FRAMING PLAN

Vermont Agency of Transportation  
**RECEIVED**  
CBS 629 Colchester, VT - Approved as Noted pdf  
 CK'D BY FDB OK'D BY HIS  
**May 5, 2015**  
 RESUBMIT Yes Rejected  
 BY Carolyn Carlson DATE 05/14/15

REV.	DATE	REMARKS	DWN	CHK	APVL	SHOP
0						
MATERIAL:		SURFACE PREP. & PAINT:	HOLES:		SHOP BOLTS:	
			-		NONE	
DESCRIPTION: FRAMING PLAN						
<b>CASCO BAY STEEL STRUCTURES, INC.</b> 1 WALLACE AVE. PHONE (207) 780-6722 SOUTH PORTLAND, ME 04106 FAX. (207) 780-6726 <small>TENCA 1415</small>						
STRUCTURE: REPLACEMENT OF BRIDGE NO. 12 ON TH27 INCLUDING APPROACH ROADWAY AND CHANNEL WORK TOWN OF COLCHESTER, COUNTY OF CHITTENDEN STATE OF VERMONT AGENCY OF TRANSPORTATION				DRAWN: BK	DATE: 04/21	
LOCATION: COLCHESTER / CHITTENDEN, VT				CHKD: YT	DATE: 04/28	
PROJ NO. STP 5600(12)				JOB NO. 629-1	DWG NO. E1	
CUSTOMER: A.L. ST. ONGE				REV.

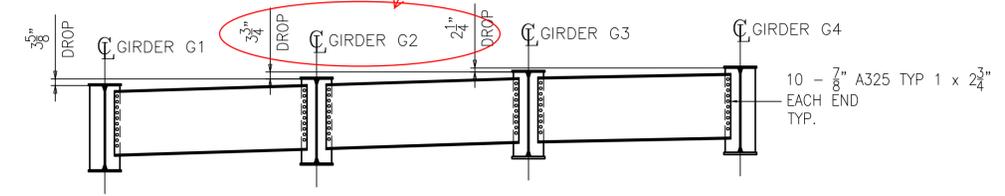
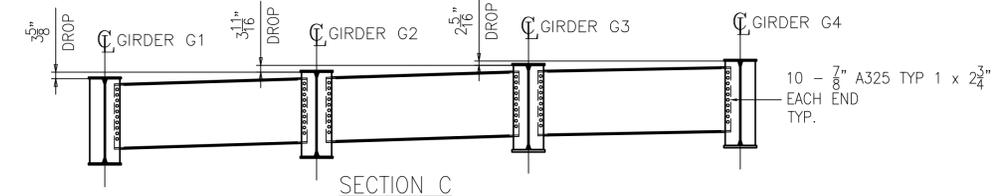
These should match section C numbers?

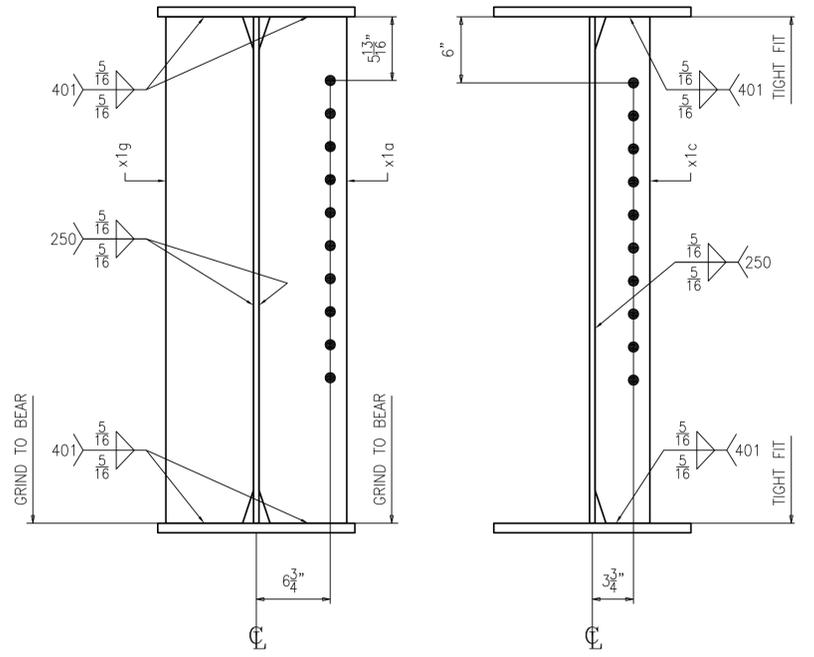
WPS 401 should be WPS 480  
 WPS 201-A should be WPS 201

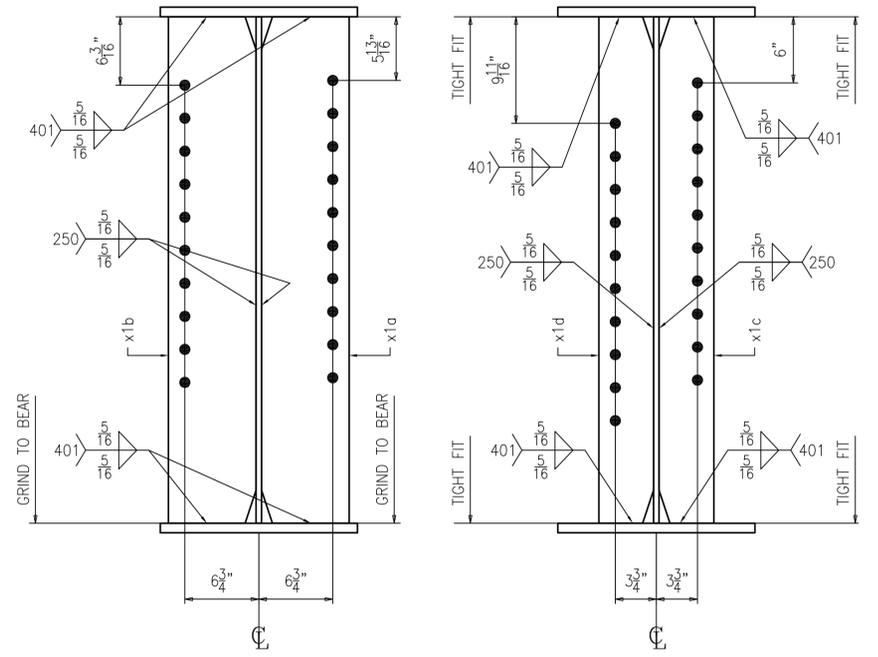
WPS 401 should be WPS 480  
 WPS 201-A should be WPS 201

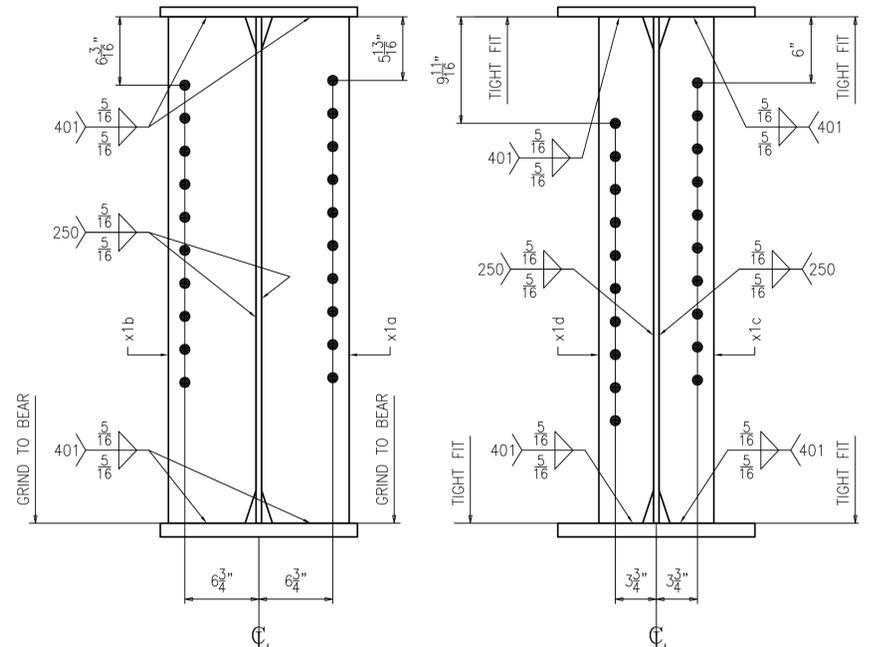
WPS 401 should be WPS 480  
 WPS 201-A should be WPS 201

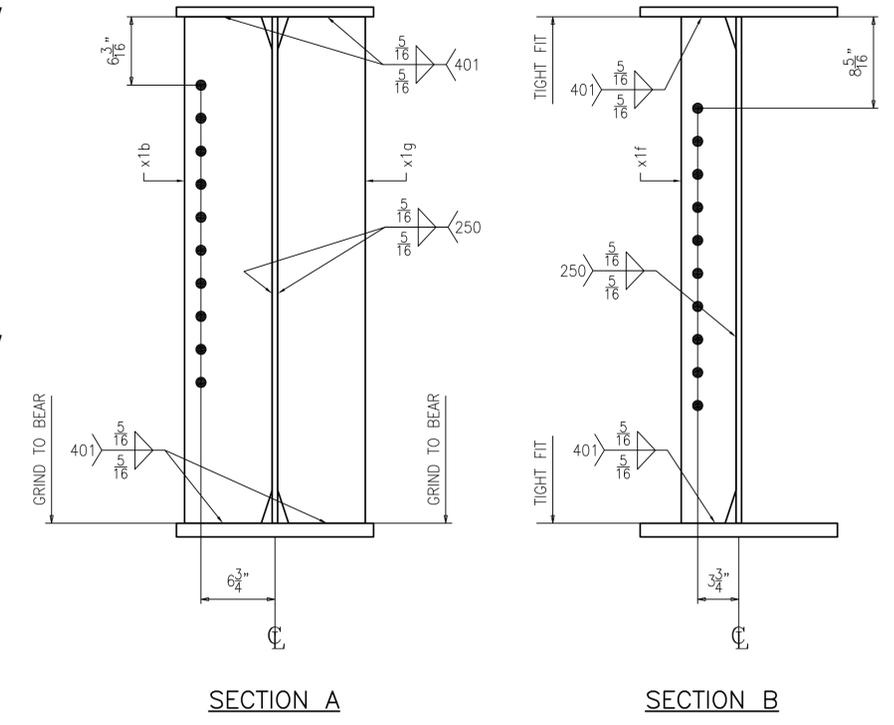
WPS 401 should be WPS 480  
WPS 201-A should be WPS 201
